**Re: Docket number 10-BSTD-01**

**October 13-13, 2011 Staff Workshop – 2013 Building Energy Efficiency Standards**

Enclosed please find ten copies of the comments of Pilkington North America, Inc. and AGC Flat Glass North America, Inc. concerning the September 2011 CASE Report for Non-Residential & High-Rise Residential Fenestration Requirements as presented at the October 13, 2011 staff workshop. These comments were delivered via email to [docket@energy.state.ca.us](mailto:docket@energy.state.ca.us) on October 31, 2011.

### Center of Glass (COG) VT vs SHGC

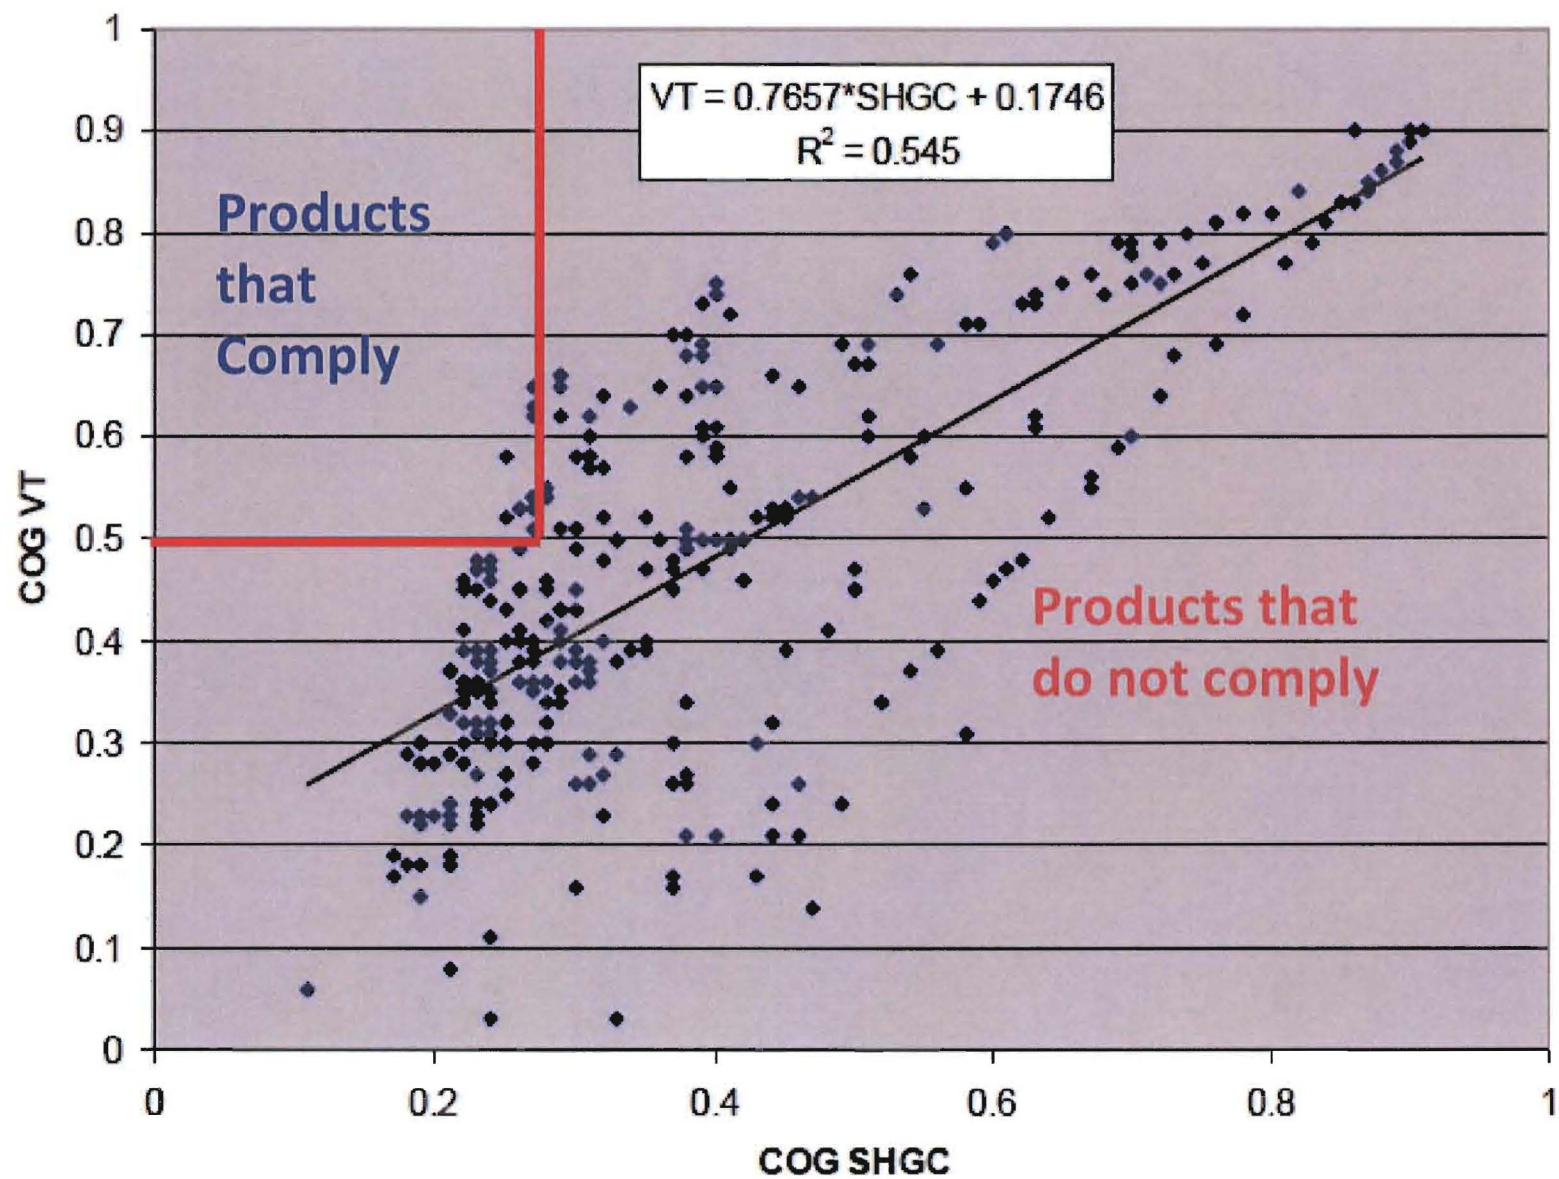
I encourage Commissioner Douglas and the other members of the California Energy Commissioners and Staff to look carefully at the Appendix to these comments. It is taken directly from Figure 7-10, page 74, of Case Report II. The graph that appears as Figure 7-10 of the Report was prepared by the Report’s Author (“Author”). It is the result of the Author’s survey of the glazing product inventories of the 6 major manufacturers’ of architectural glass.<sup>5</sup> It

The graph in the Appendix is identical to Figure 7-10 in the Report, except that it adds (i) the vertical red line (ii) the horizontal red line (iii) the words “Products that Comply” and (iv) the words “Products that Do not Comply.” The vertical and horizontal red lines on the graph separate the products that comply with the prescriptive criteria proposed in the Report from those that are disqualified from compliance by the prescriptive criteria proposed in the Report.

The dots within the red box in the upper left hand side of the Appendix are marked “Products that Comply” because they represent the only 15 glazing products that do comply with the VT and SHGC criteria proposed in the Report. All of the other dots on the graph represent products that do not qualify or meet the VT and the SHGC criteria proposed in the Report. The 317 dots in the area marked “Products that do not comply” represent the 317 products that do not comply with the VT and SHGC criteria proposed in the Report, although they are currently available in the marketplace.

If adopted, CASE Report II would eliminate 302 of 317 products that are available in the market but that do not comply with the prescriptive criteria proposed in the Report. This means that, in an effort to “simplify” its code, California would exclude 95.3% of all products from competing for compliance with the prescriptive provisions of its energy code. Whether intended or not, adopting the Report’s proposed criteria would create a prescriptive monopoly in California consisting of only 4.7% of the glazing products currently available in the market.
